# RCRBD Record Set

MORAN STEEL BUILDING  
LONESOME BEAR RANCH  
ROUTT COUNTY, CO.

RCRBD  
PERMIT # TB-19-830  
3/19/20

The following list is a direct response to the items listed on the Plan Review Comments requiring corrections:

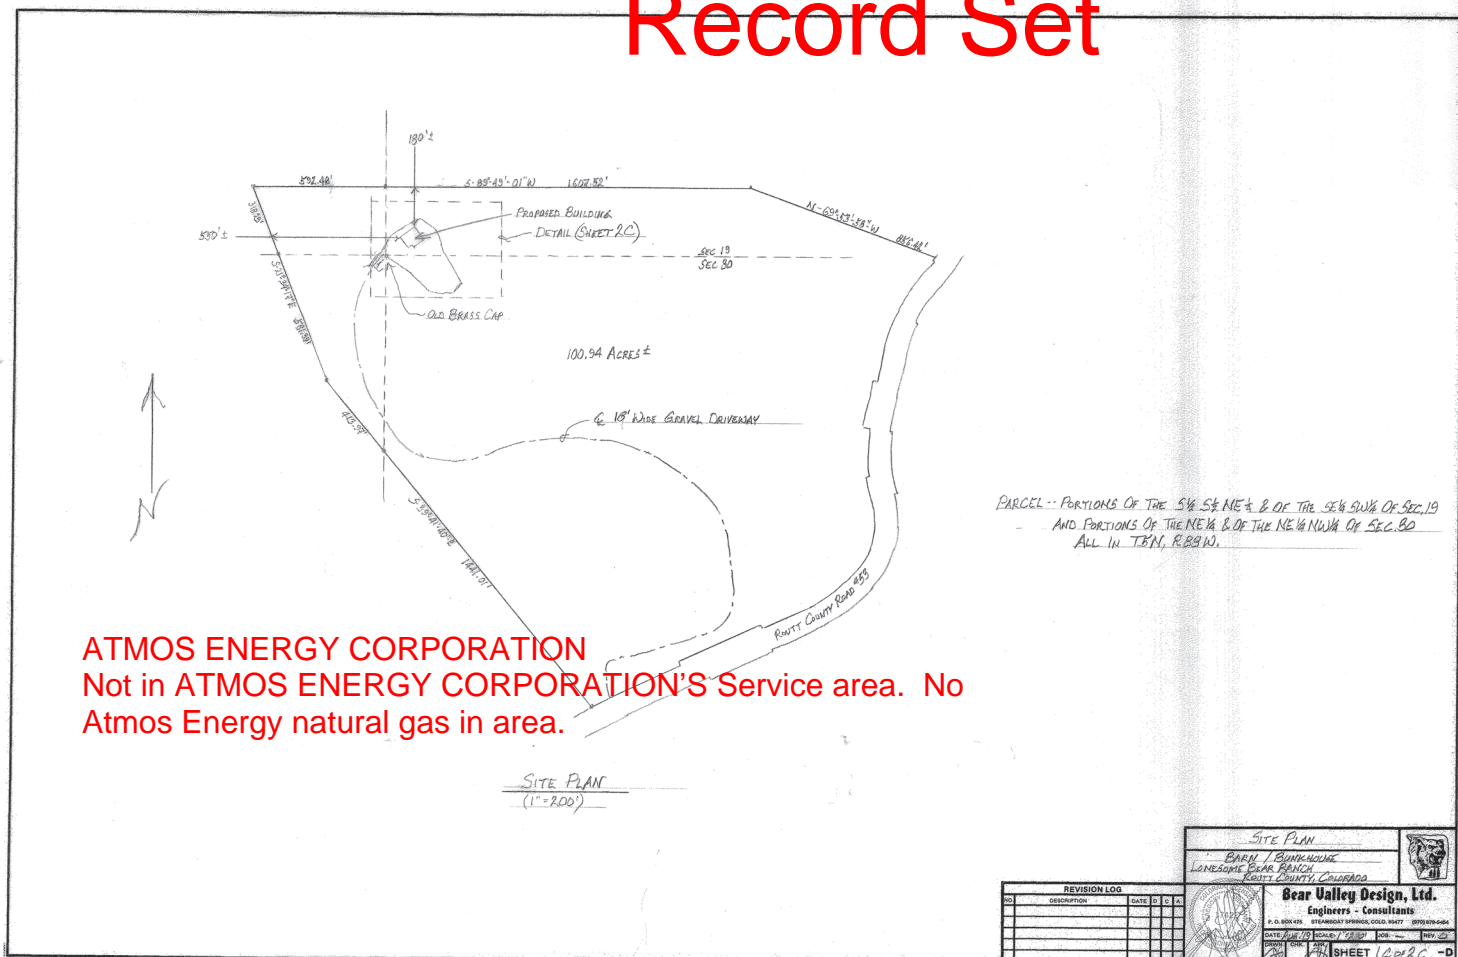
Meter Location will be determined after on site visit with YVEA Craig Field Representative. Meter & meter pedestal are to be located as described by YVEA. They shall not be enclosed, covered or concealed. Violation shall result in termination of service.

Yampa Valley Electric Assn. INC  
This Approval addresses only  
the meter and service location  
Approved: Scott Flowers - YVEA 10/01/19

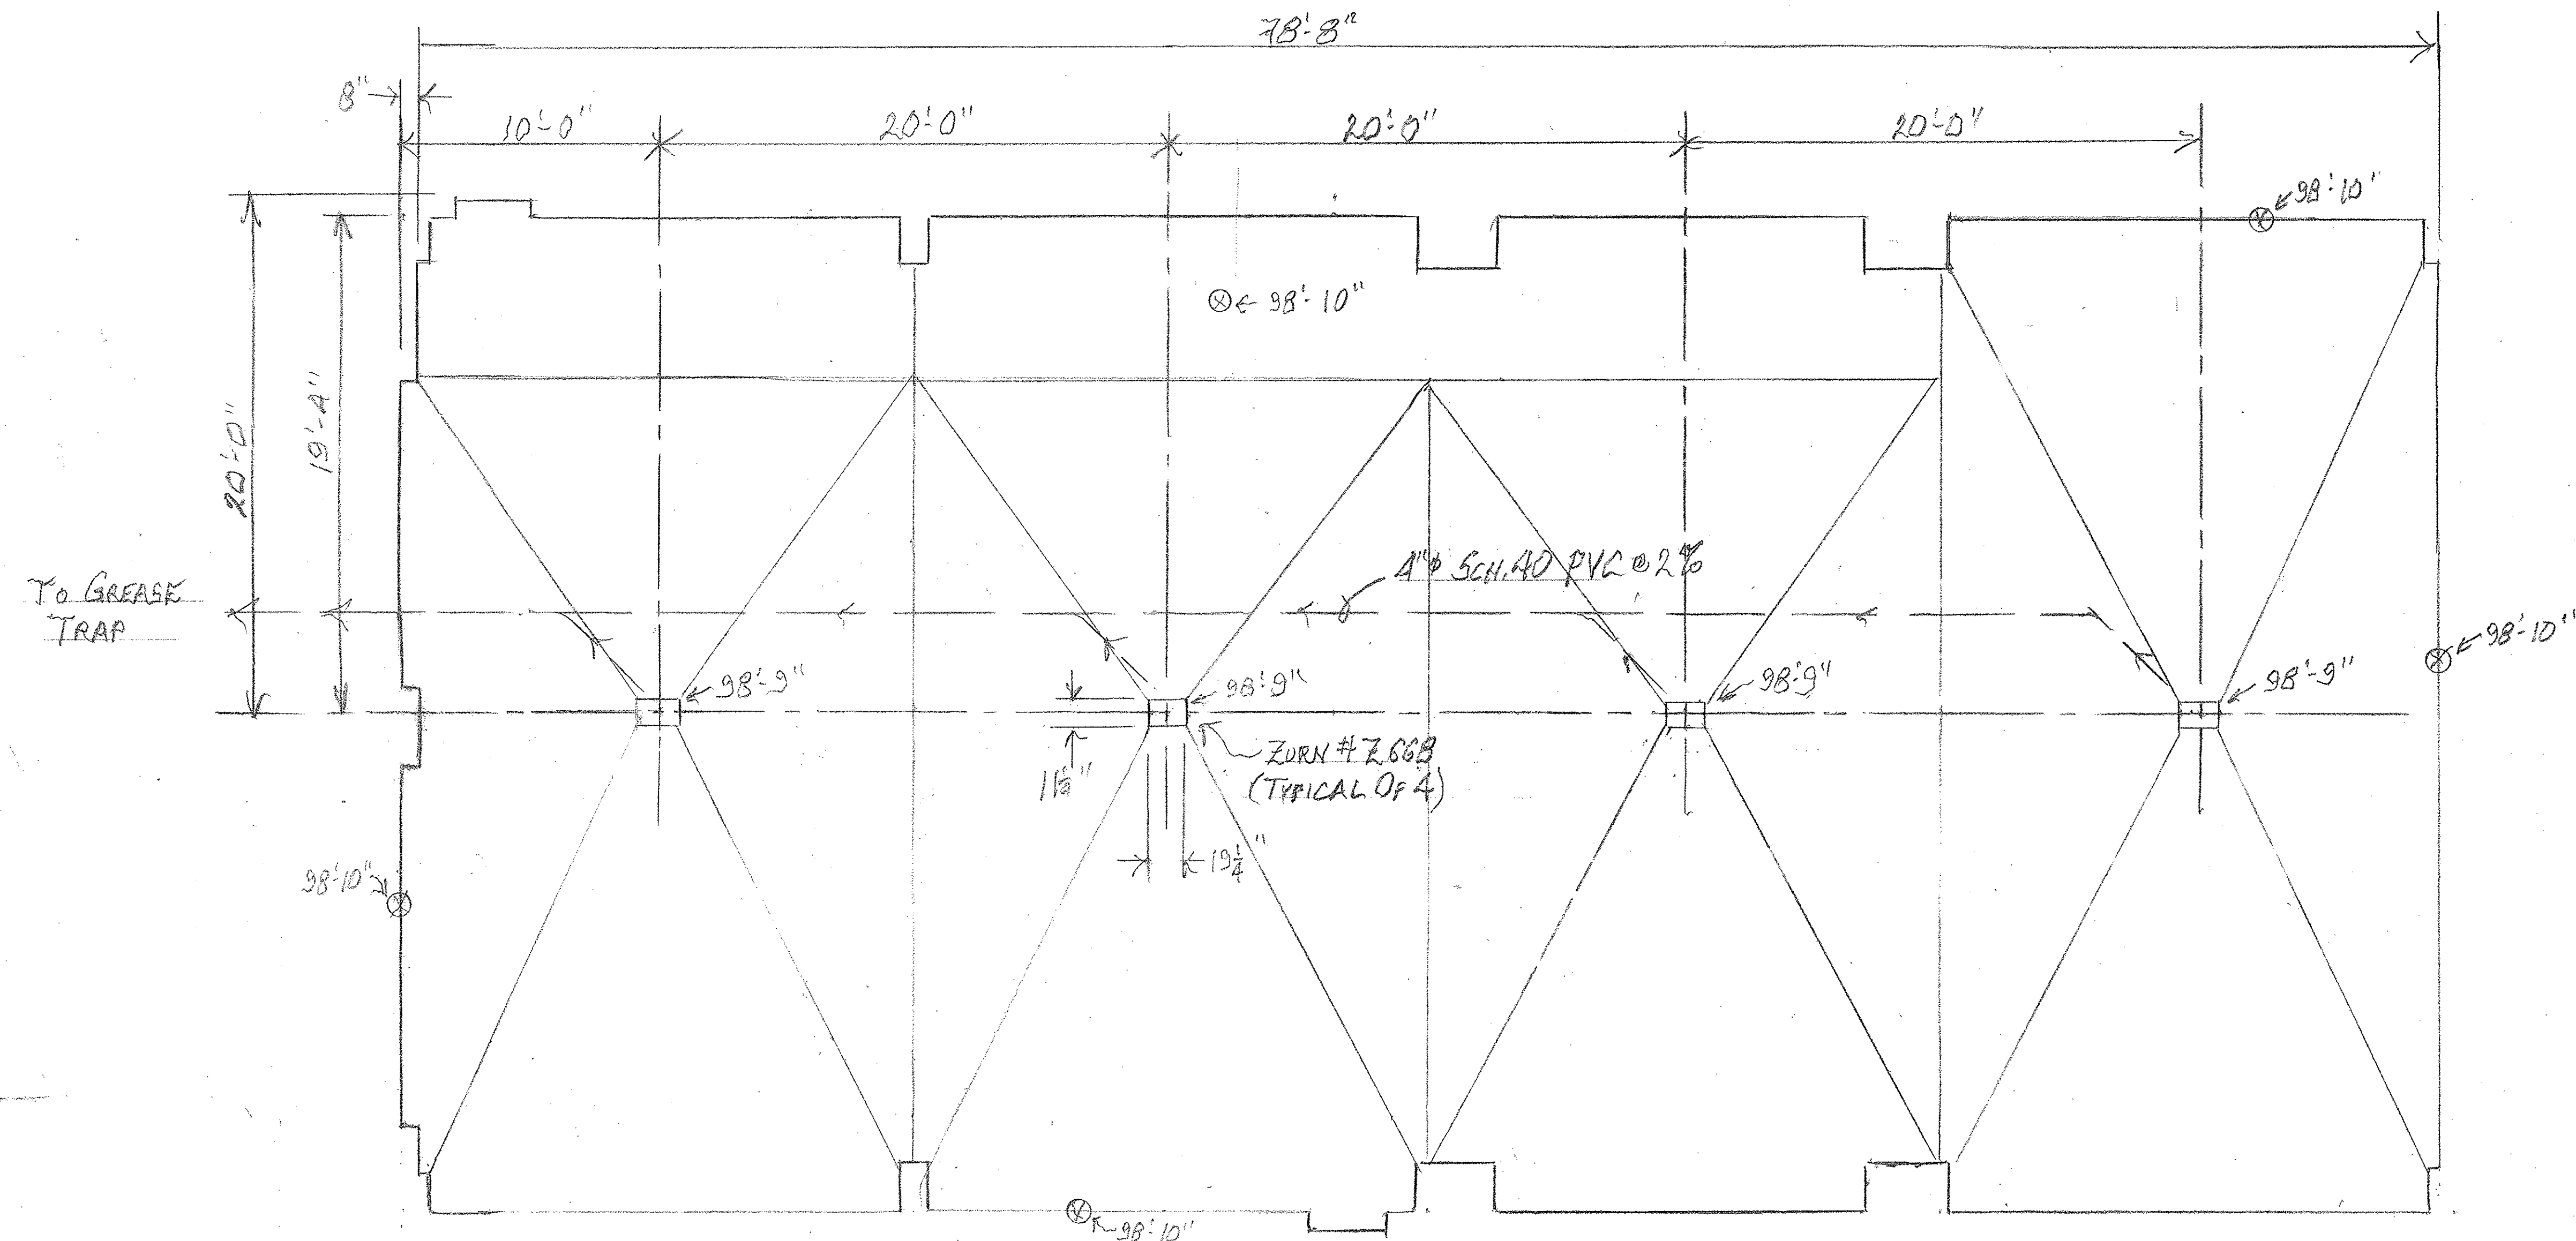
Per our discussion this afternoon, Mike and I will be working with Scott Myller in order to address all of the issues you have raised with respect to occupancy separation and other 'upstairs' issues in the subject building.

Yes, the slab on the main floor will incorporate hydronic radiant heating, and insulation under the slab, between the 'Barrier' vapor barrier I specified on the drawing and the foam material (with buttons for locating the tubing) with have an R value of at least R5.

The anchor bolts will be as follows:

3/4" D., imbedded in the pilasters (5 locations on each side) will be 36" long with a 4" right angle hook at the bottom and 5" length of 3/4" D. UNC thread at the top.

3/4" D. imbedded in the end walls for end wall columns will be 18" long with a 3" right angle hook at the bottom and 5" length of 3/4" D. UNC thread at the top.

All 1/2" D. bolts for miscellaneous door frame attachments may be typically available commercial drill in type cinch anchors.

All 3/4" bolt shall be either of A-36 steel or meet the building manufacturer's noted 'F1554' spec, whichever is more stringent.
